September 7th, 2018

Subject: ST3 WSTBE Level 2 preliminary recommendations

ST3 Level 2 Station, Water Crossings,
& Alignment Recommendations

SODO Station

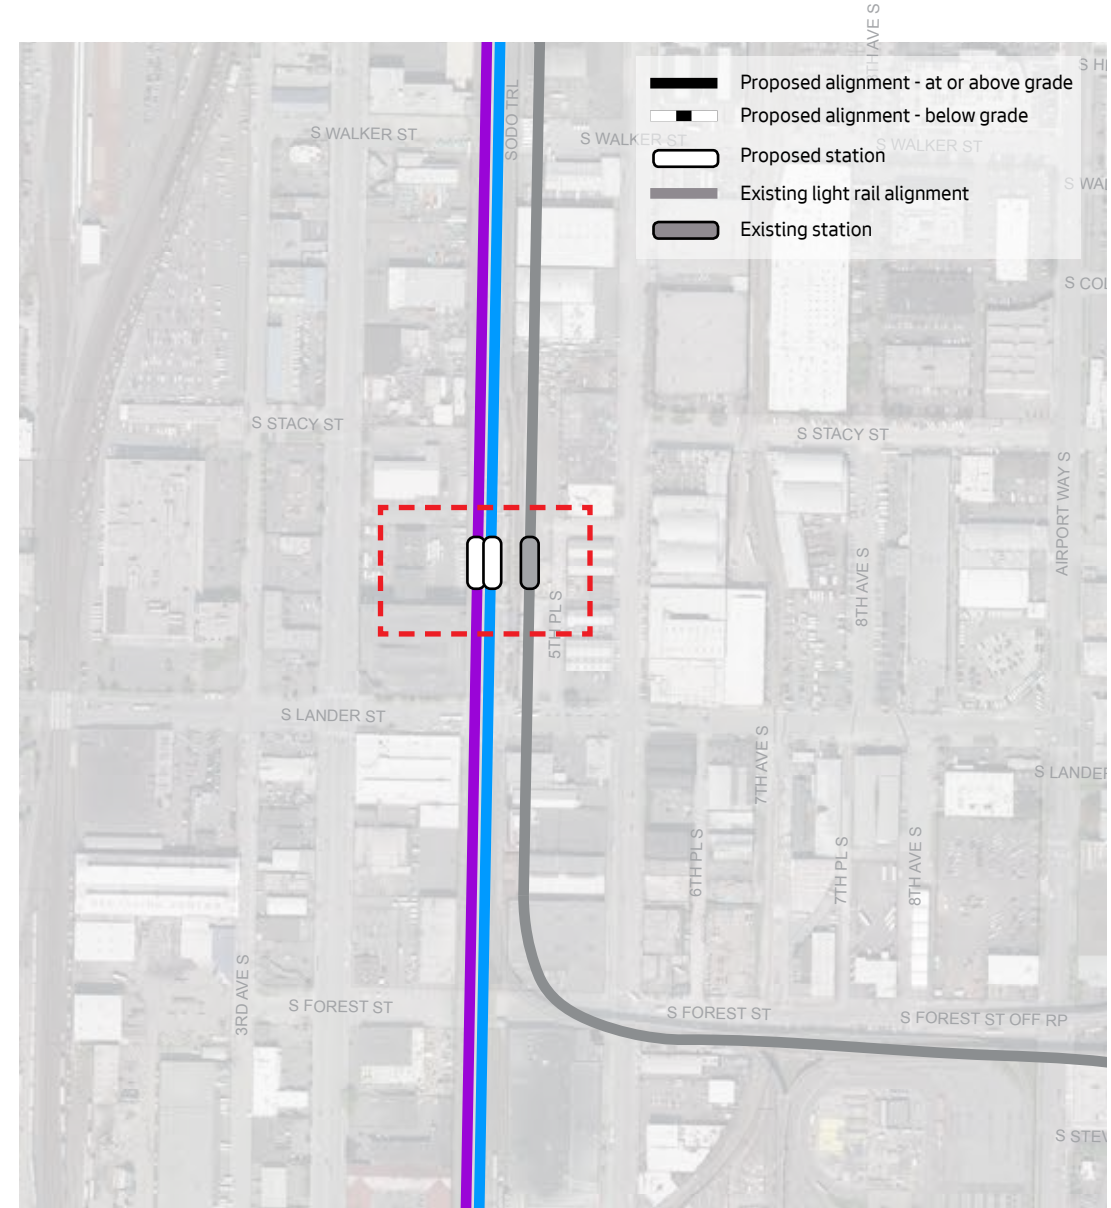
1. E-3 corridor east of current station, at grade with shared platform
2. First Ave or another western location

- Provide a transfer strategy between light rail and high volume bus lines - Eastside, SeaTac Airport, West Seattle, Tacoma
- Plan for bike share and other means to connect from station out into this important employment center

- E-3 corridor provides essential connections between employment areas and affordable residential areas to the south. Explore and use data on these jobs and housing connections that are increasing due to population growth in these areas.

Stadium Station

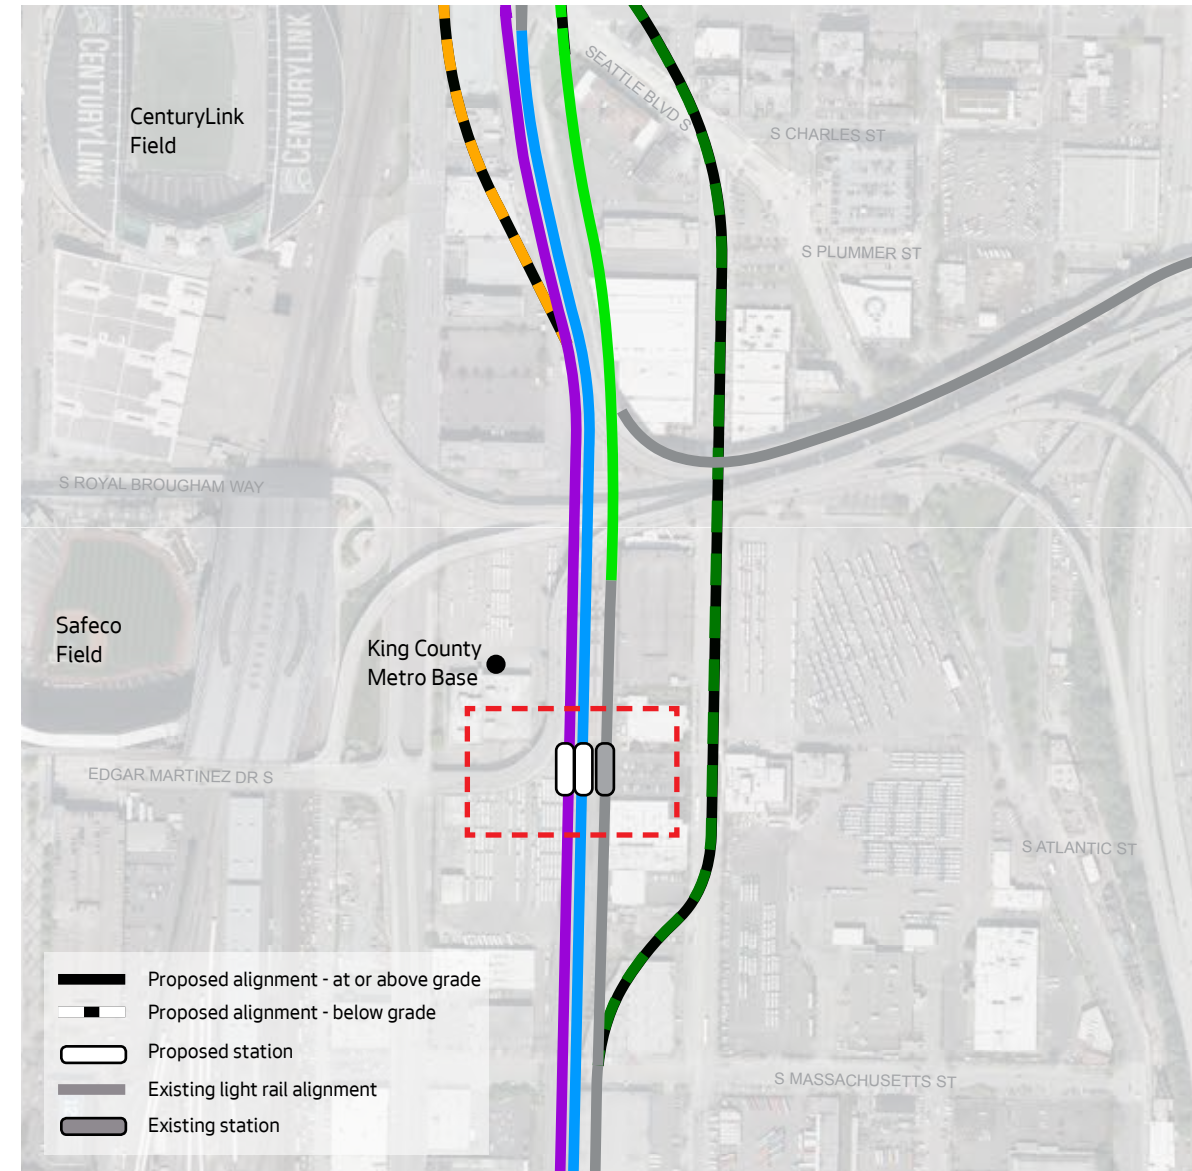
1. Near the existing station, at grade with a shared platform
2. First Ave or another western location

- Strongly support locating a station that serves the stadiums for greater choice and connectivity

- Provide for transfers directly across one platform
- Connect any new station with the existing stadium station to maximize transfer to and bet ween alignments
- Consider physical and functional relationship to Greyhound station
- Provide for food services/retail and restrooms at this station

Chinatown ID Station (part 1)

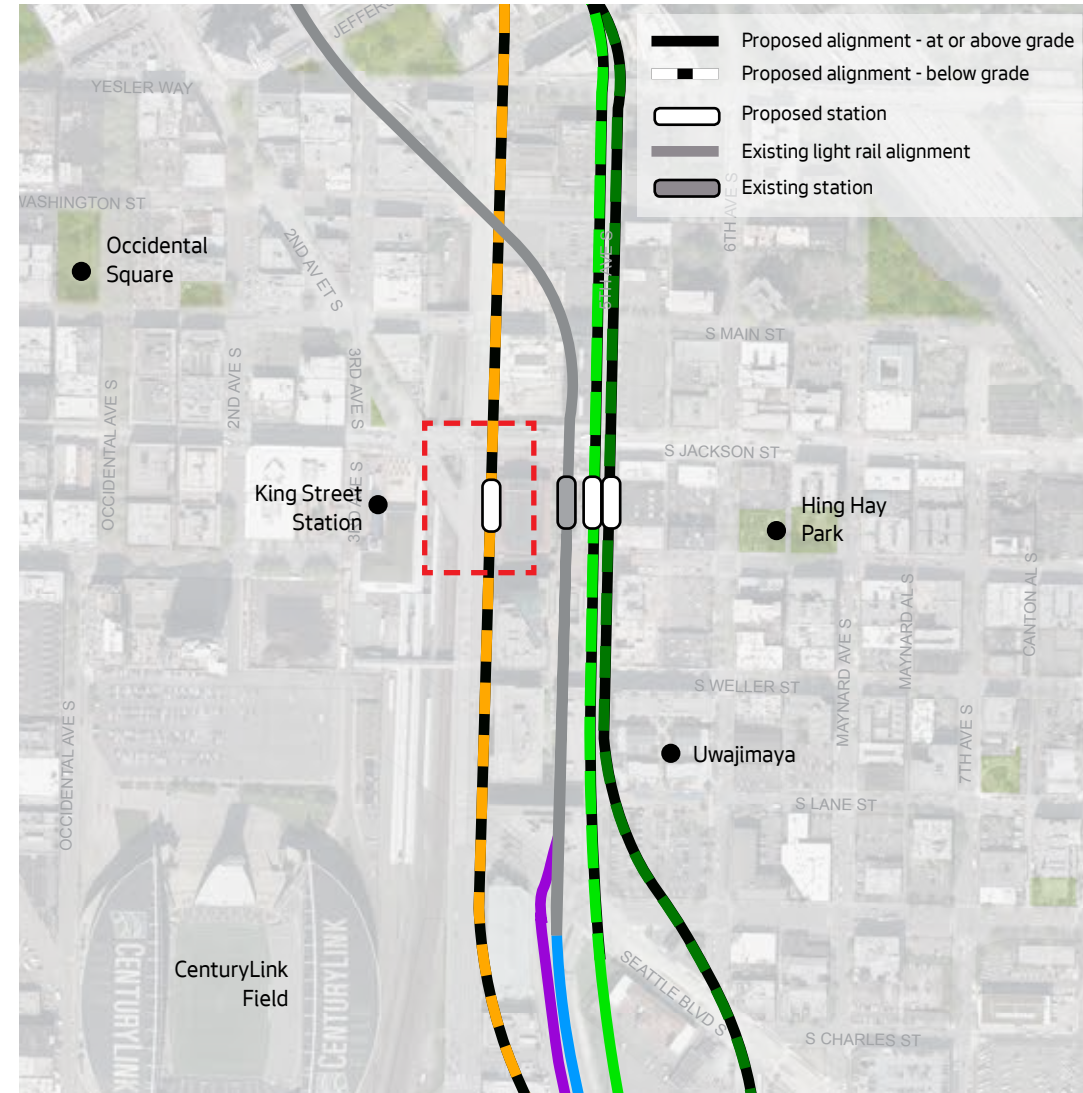
1. 4th Ave and Union Station
2. A location north of Jackson St

- Designate Union Station as the light rail station, consistent with its original historic purpose
- Locate and design station and surrounding areas to be a cohesive intermodal hub for light rail, buses, streetcar, and other modes of transportation in recognition that the CID station area is a major regional transit and civic hub.

- Explore joining Union and King St Stations into one public authority (PDA, CDC, etc.)
- Develop the Union Station and adjacent public open space to be a cultural hub as it reflects the community's desire for a central space. Recognize the potential to reconcile historic injustices to businesses and the community.

- Make the most of the potential for culturally informed economic development. Given the regional draw of cultural events and amenities here, the station is in an optimal position to support transit access.

- Create a physical connection between Union Station and King Street station to enhance intermodal and neighborhood accessibility
- The City should consider investing in the 4th Ave alternative given the poor condition of the substructure. The City and ST should provide joint funding to replace the 4th Ave Viaduct.

Chinatown ID Station (part 2)

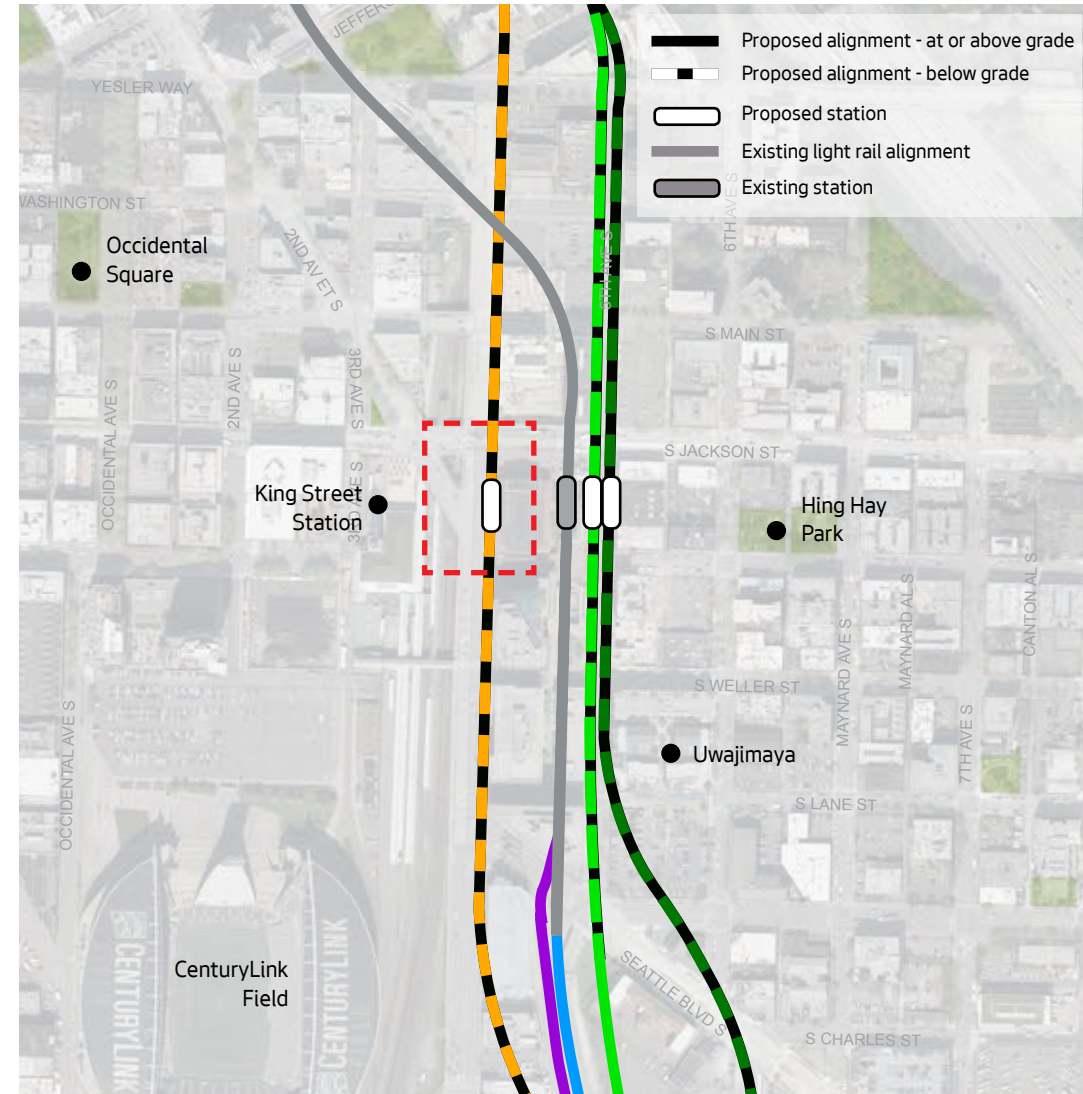
- Advise against a 5th Ave station due to its impacts to culturally significant local businesses and to traffic mobility. If 5th Ave is only option, construct through deep bore tunnel instead of a cut and cover station to reduce impacts on neighborhood

- Advise against a deep bore tunnel that results in a new station under the existing CID station. The stacking of stations in this location poses significant challenges to pedestrian movement between light rail alignments and the other transit modes that serve this station.

- Analyze and weigh openly the long and short term advantages and disadvantages to the 4th Ave alternative. Short term construction impacts shouldn't take precedence over better neighborhood integration

- Consider the economic cost of poor/limited transfers between light rail lines and other transit options (buses, streetcar, etc.). 20% of King County buses pass through here.

Consider a location north of Jackson if the 4th Ave alternative isn't possible

- Provide pedestrian tunnels under Jackson to connect to the CID station
- Solution creates longer connection to King Street Station
- Strongly recommend against any alternative that is in the Jackson right-of-way because of impacts to transit and traffic.

Whether the station is located in 4th or 5th, develop a plan to reduce short and long-term traffic impacts given its role as a carefully plan for as a hub between Central District, Beacon Hill and downtown.

Midtown Station

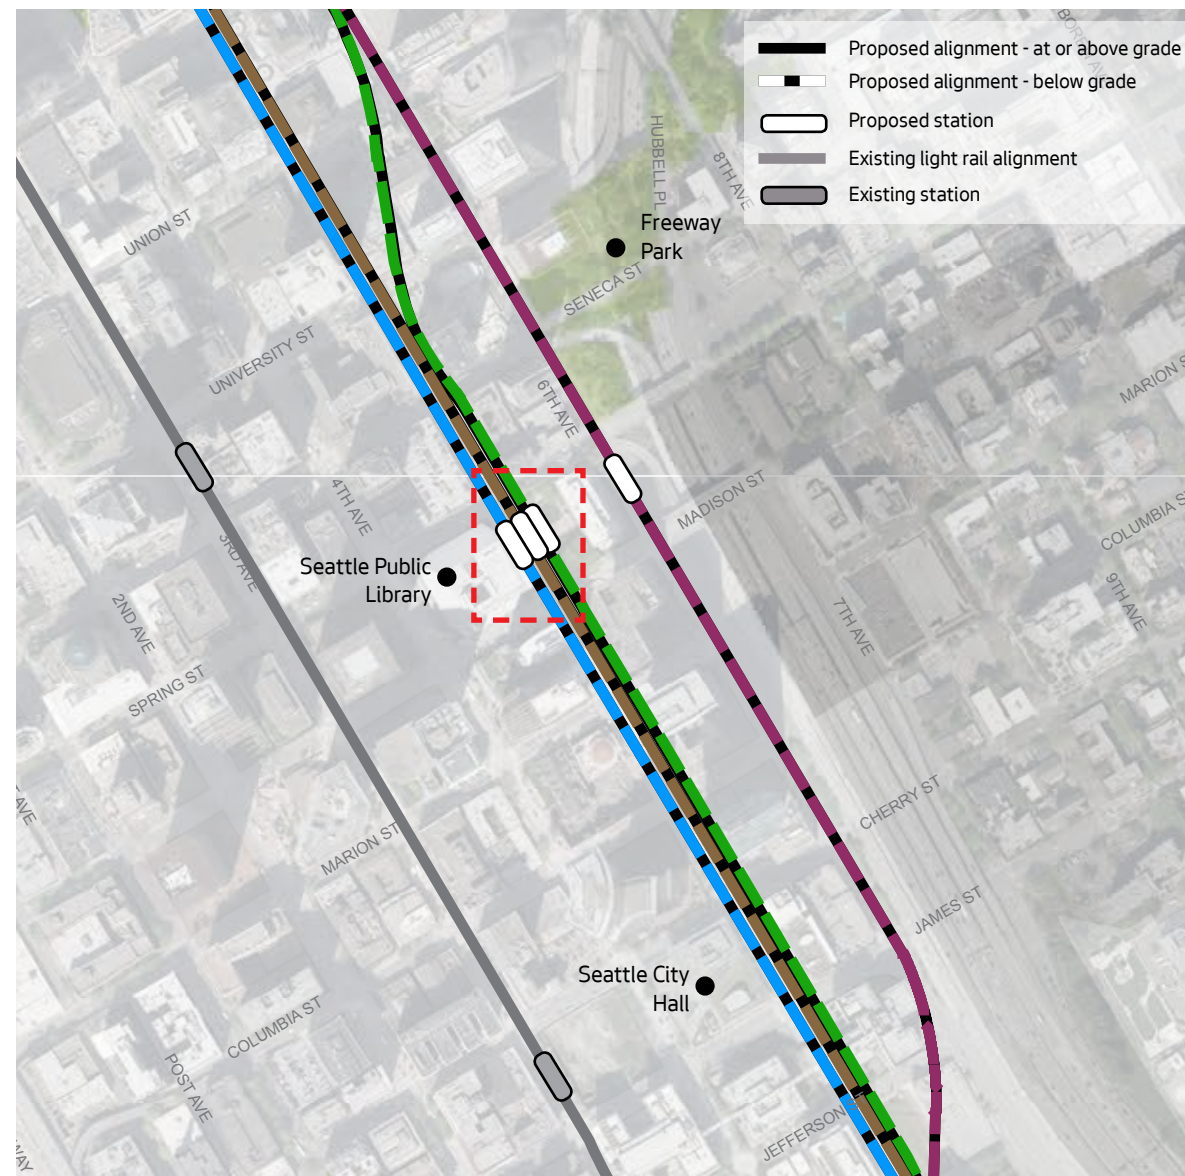
Study : 5th Ave near Madison St

- This location is closer to the proposed Madison BRT stop between 4th Ave and 5th Ave
- This location has less intense existing use of curb space

- Improve pedestrian connections across I-5 to businesses and residents in First Hill neighborhood

Westlake Station

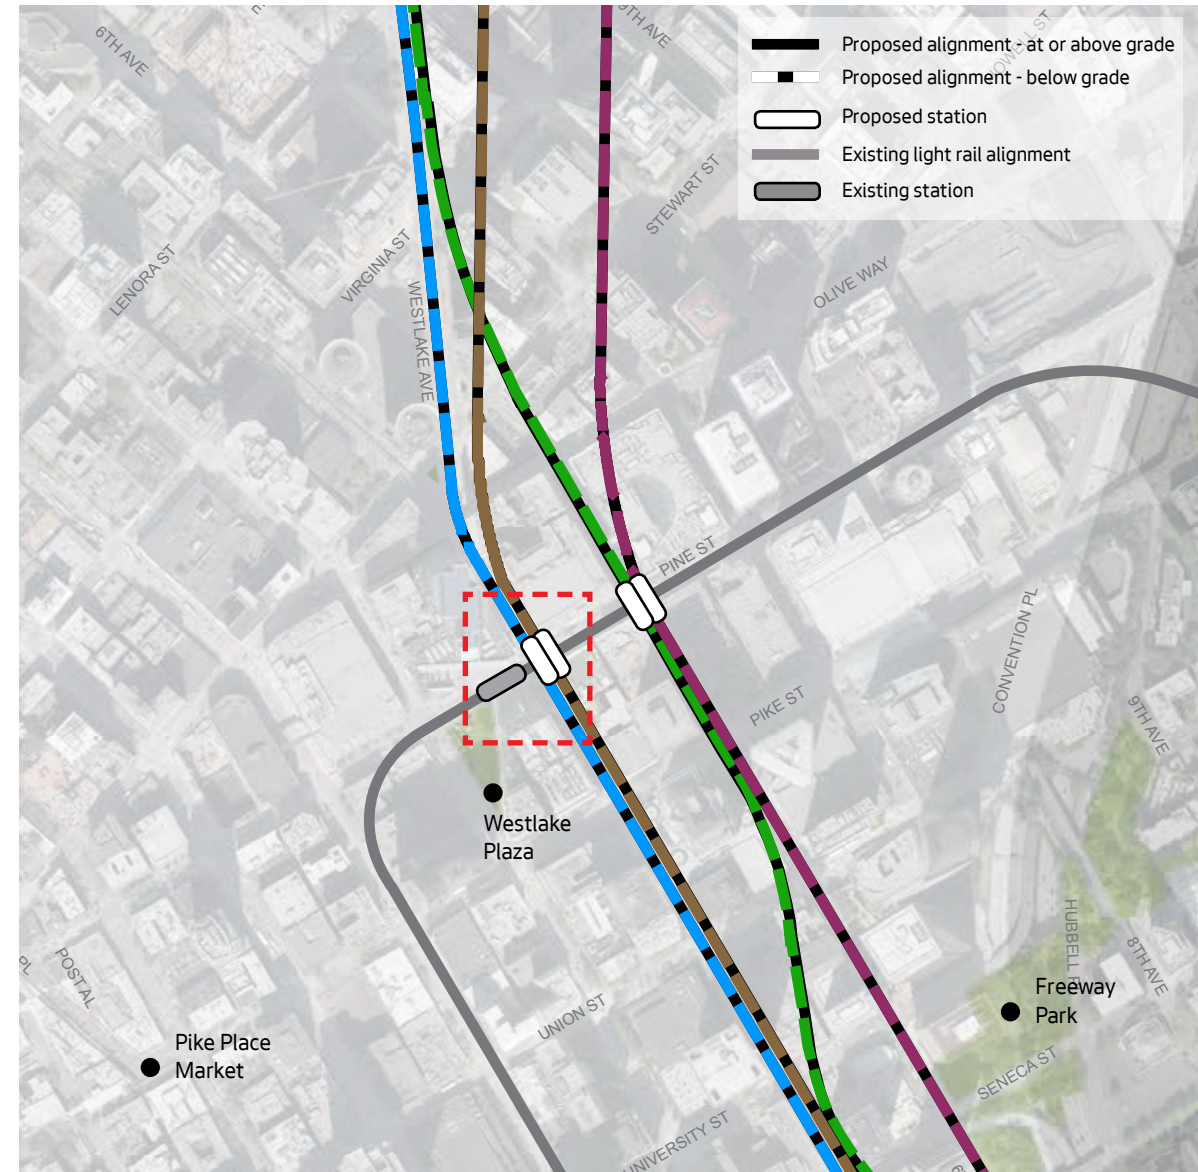
1. 5th Ave location
2. 6th Ave location

- 5th Ave will provide superior transit connections because it is closer to
 - Existing Westlake Station
 - 3rd Ave transit corridor
 - Regional buses on 4th and 5th
 - SLU streetcar station at McGraw Square

- If along 6th Ave, provide accessible tunnel between existing and new stations

South Lake Union Station

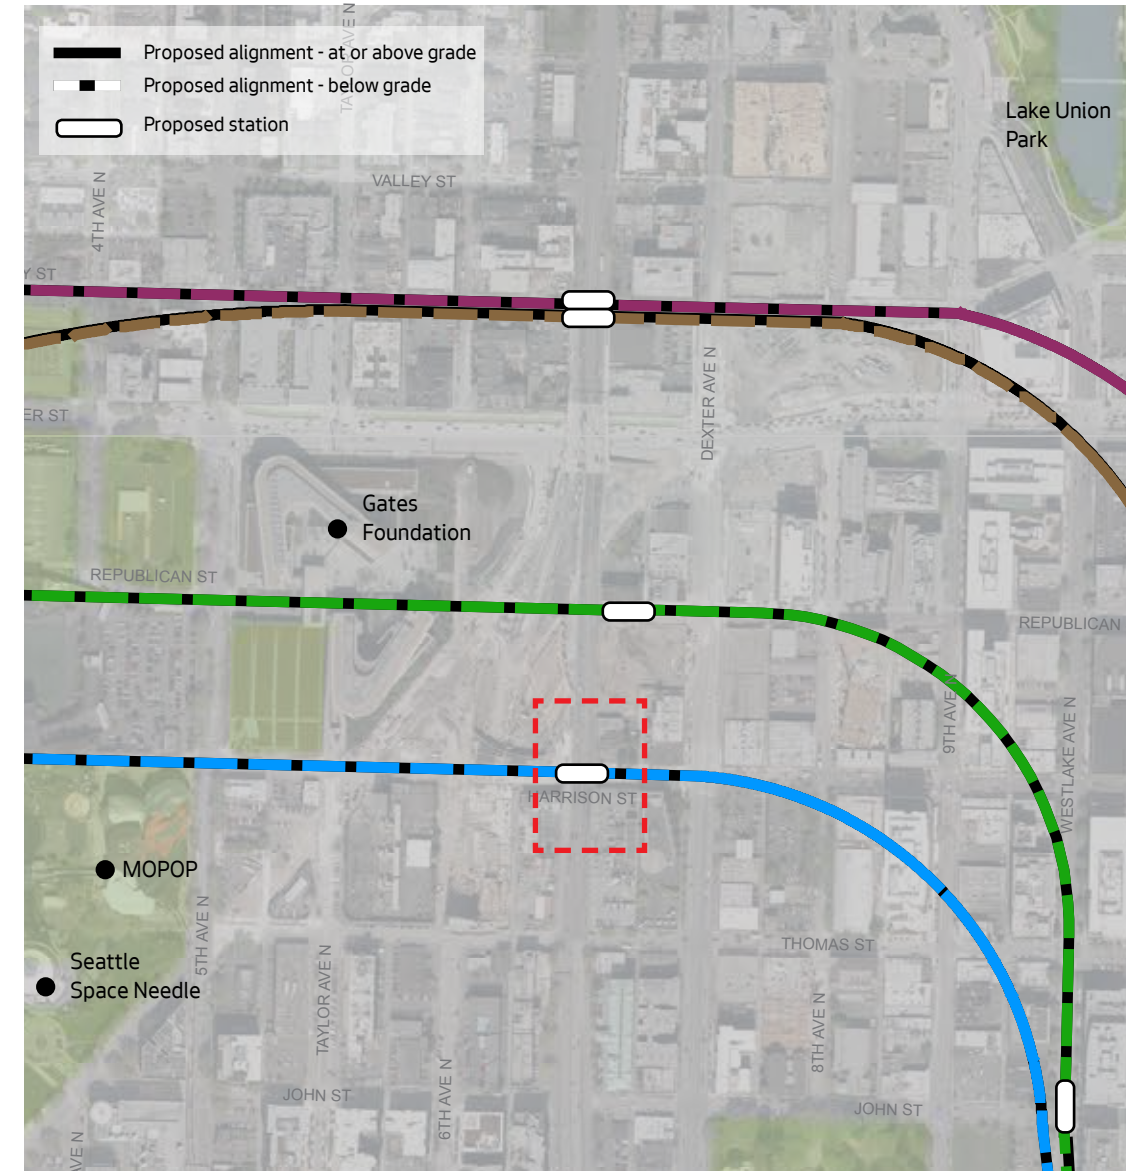
1. Underground at Harrison on the west side of Aurora Ave N

- City and state investments (North portal, reconnecting grid, etc) in this vicinity included generous design of right-of-way to accommodate Harrison as a transit street
- Zoning around Harrison would likely generate higher ridership

- Provide east/west connectivity across SR 99 at Roy and other streets that will not be connected in the near future
- Study the additional complication and cost of running the tunnel between SLU Station and the Seattle Center Station diagonally instead of along just one road (mix and match)
- Provide and consider information on the future east west bus service along Harrison
